CERTIFICATE OF APPROPRIATENESS

Property: 638 Heights Boulevard, lot 22, block 277, Houston Heights Subdivision. The property includes a historic 1,108 square foot, one-story wood frame single-family residence situated on a 7,500 square foot (50' x 150') interior lot. The property has previously received a COA for foundation repair and brick stabilization on June 19, 2014 and a COA for a rear two-story addition on October 23, 2014.

Proposal: Alteration – Revision. The applicant has exceeded the approved scope of work by removing the existing brick veneer, a portion of the original roof and reframing it at an increased height, some of the original windows, and the non-original front door. All original materials were to remain as stipulated in the previously approved COAs. The applicant now proposes to take the following remedial measures:

NORTH SIDE ELEVATION

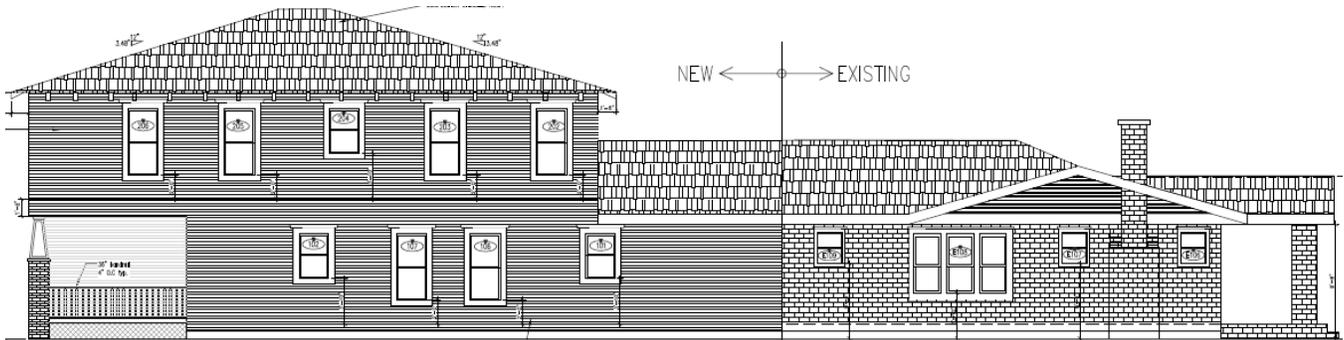
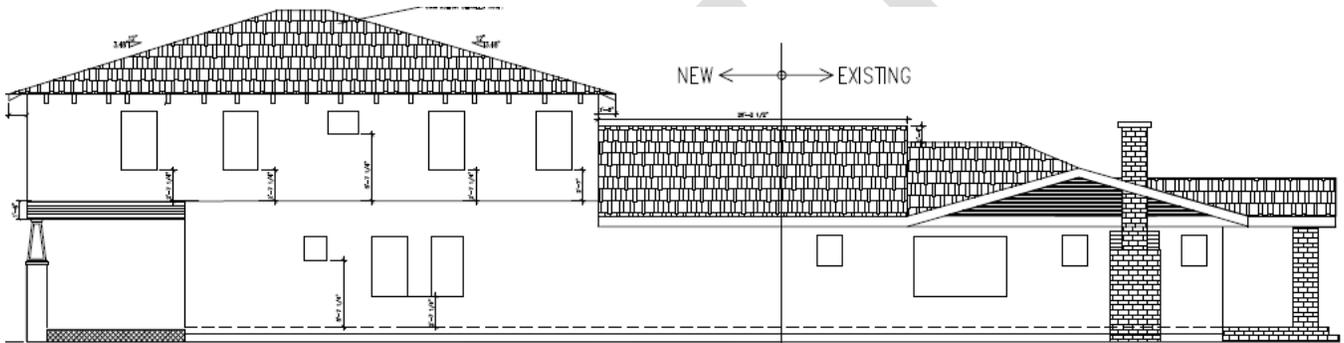
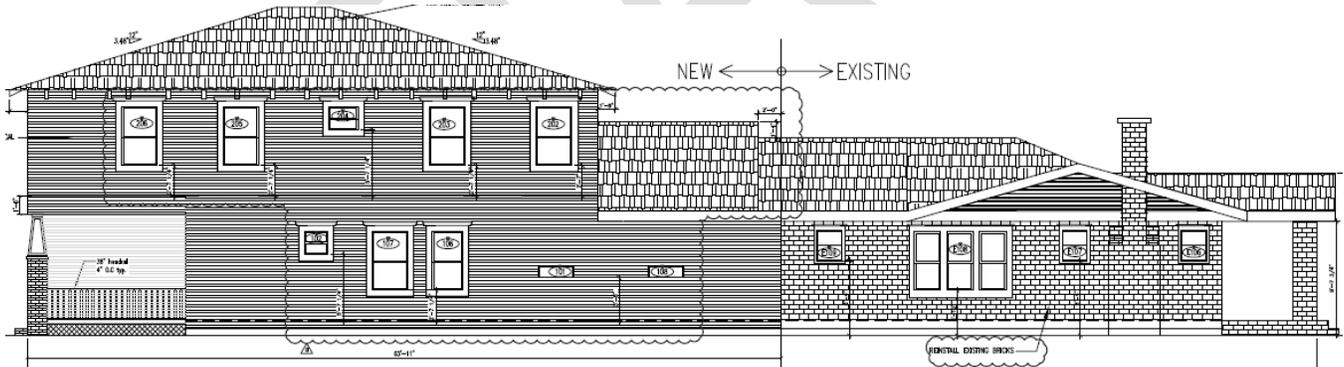
Side Elevation: The original house features six windows, all of which were removed and retained on site and will be repaired and reinstalled. The addition was approved to have three windows on the first floor and five windows on the second floor. The addition will feature two more windows on the first floor for a total of five.

SOUTH SIDE ELEVATION

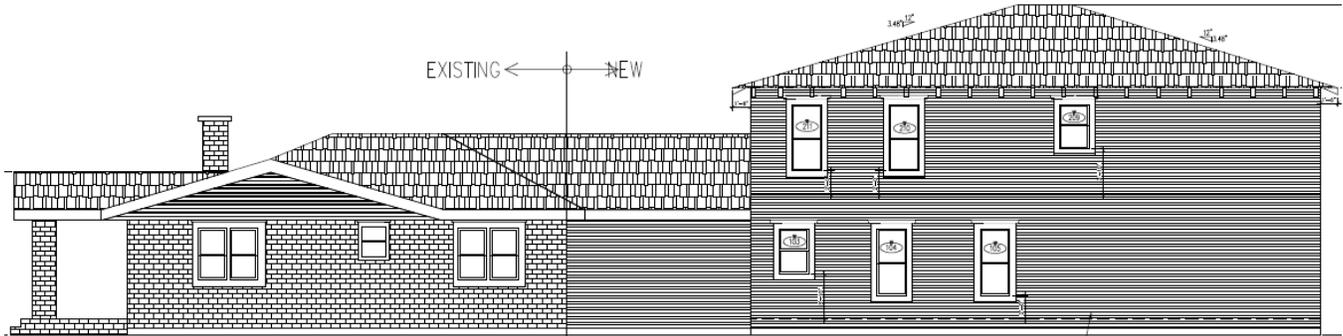
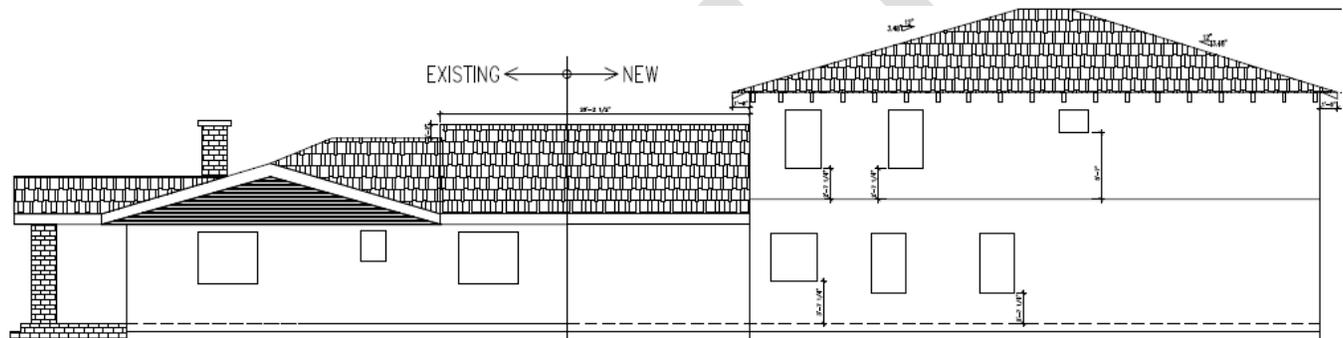
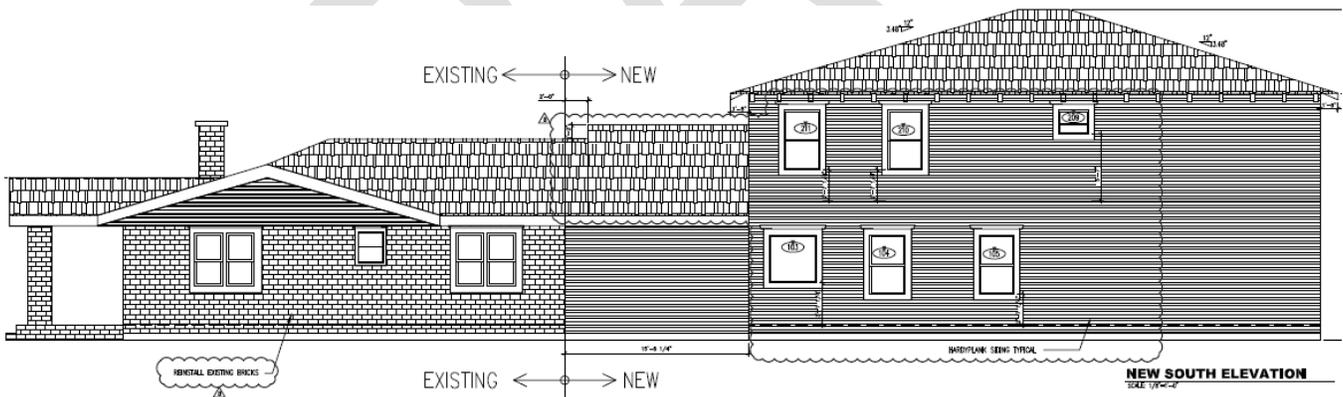
Side Elevation: The original house features two pairs of windows and a single window, of which one pair is still in place and will remain. The other windows were removed and retained on site and will be reinstalled. The addition was approved to have three windows on the first floor and three on the second floor. Their locations and sizes have been altered slightly.

DEMOLITION PLAN

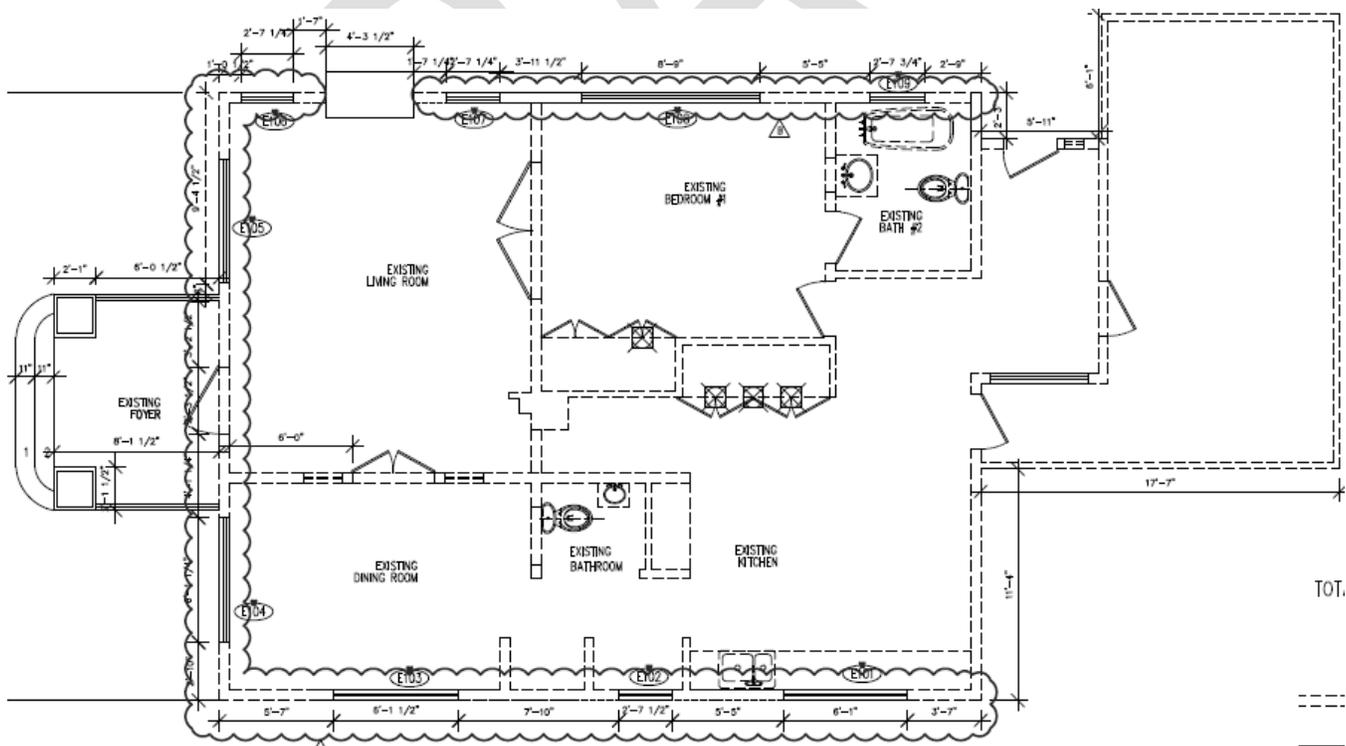
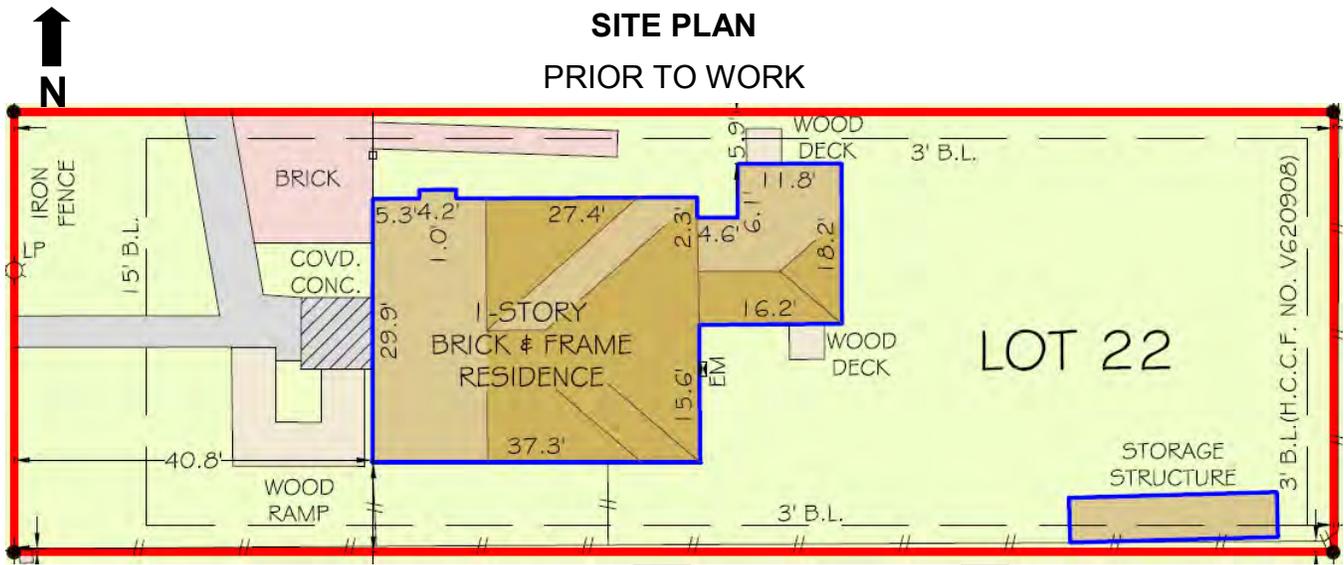
Exterior Materials: The existing residence was clad in painted brick veneer. During construction the original brick veneer was removed. Only the original porch and chimney remain.

Much of the original brick remains on site and the applicant proposes to reinstall the brick which will be supplemented with antique brick to match existing. The addition will now be clad in cementitious siding and not beveled lap siding as previously approved. The original shiplap was removed and the house was reframed. See photos and drawings for more detail.
